Town of Parker Community Development Department
Development Review Division
Attention: **Ashley Chasez**

Application Type: **Site Plan**
Status: **First Referral**
Application Name: Crown Point F1 AMD 20 L4E - Land of Sushi
Case/AP#: **SP23-006**
Referral Received: February 21, 2023
Comments Due: March 21, 2023

TOWN OF PARKER - FIRE/LIFE SAFETY:	R REVIEWED FOR CODE COMPLIANCE; REVISIONS REQUIRED
---	---

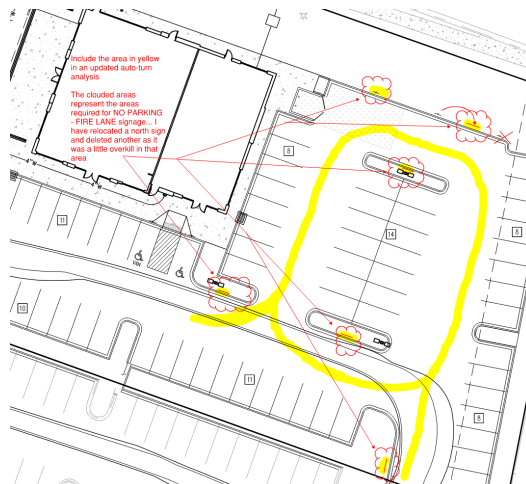
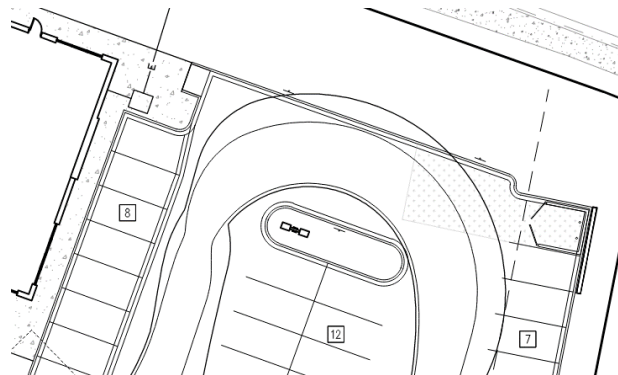
2. During the pre-application meetings, the need to provide a fire hydrant on site... this was not addressed. A fire hydrant will be required at the s/e island by the s/e corner of the building. See the redlined drawings and the detail below for the location of the required fire hydrant. *Satisfied; applicant noted or acknowledged or addressed with second submittal.*

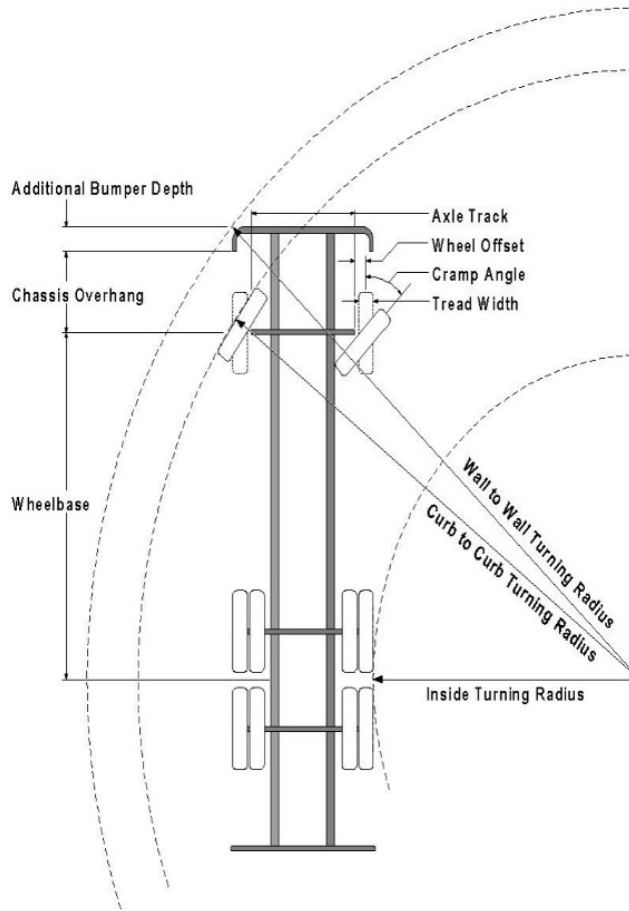
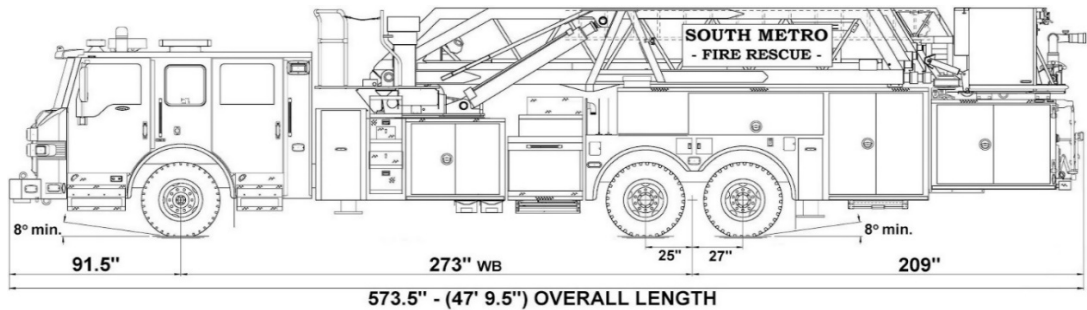
7. While the applicant has provided an auto turn analysis, the applicant has not addressed the access on the eastern portion of the site. When resubmitting, the applicant shall provide an auto turn analysis indicating that apparatus can **navigate all portions** of this site (east side of the building); NO PARKING – FIRE LANE signage is required for any portion of the access where the 20-foot clear width requirement cannot be met. See below for the areas **required** to be included in the auto turn analysis (in addition to what already has been shown) and address when resubmitting: *Not satisfied; applicant has provided the required area for the analysis though the auto turn shows quite a bit of encroachment into the landscaping on the north end. Clean up the analysis to ensure access when resubmitting.*
